North Anna 3 COLA

NRC-Dominion Weekly Licensing Call

Follow-Up Questions to March 23-25, 2016 Fuel Audit

April 7, 2016

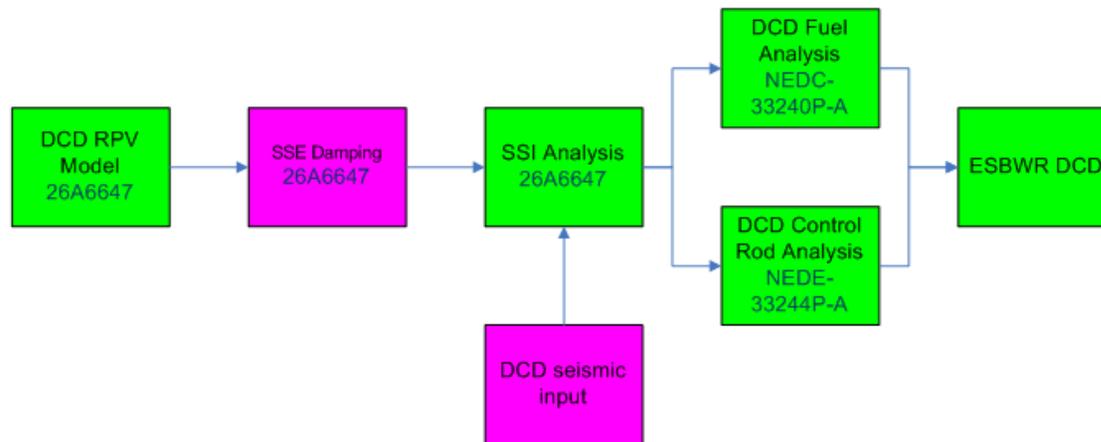
For the fuel assembly seismic response analysis, clarification of the methodology or methodologies used to calculate the maximum horizontal acceleration from the maximum X and Y directional accelerations calculated via the primary structural model. Specify if the fuel assembly seismic response analysis methodology report a maximum from the X or Y direction values, or if the methodology then calculates a resultant acceleration from those values. Describe the justification for the method/s used.

- Used same methodology as that used for the DCD (see next slide). Selected maximum acceleration in X or Y direction from primary structural model (SER-DMN-019) and compared it to fuel mechanical design limit. The maximum accelerations are selected from all cases, time-steps, and fuel nodes.
- Justification: 10 CFR 52, Appendix E, Section VI

NA3 Fuel and Control Rod Seismic Overview

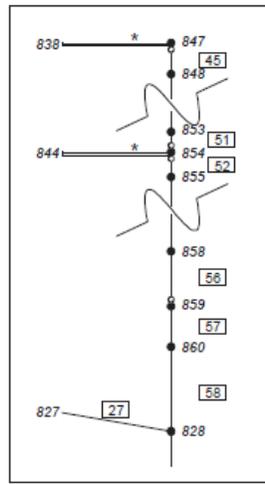
For the fuel assembly seismic response analysis, please clarify the methodology or methodologies used and specifically describe which axial node is used in determining maximum horizontal accelerations.

- Used same methodology as that used for the DCD (see previous slides). Selected maximum acceleration in X or Y direction from primary structural model and compared it to fuel mechanical design limit.
- Used Node 854 (bottom of fuel node) to determine maximum horizontal acceleration (Reference SER-DMN-019, Table 4.2-5)
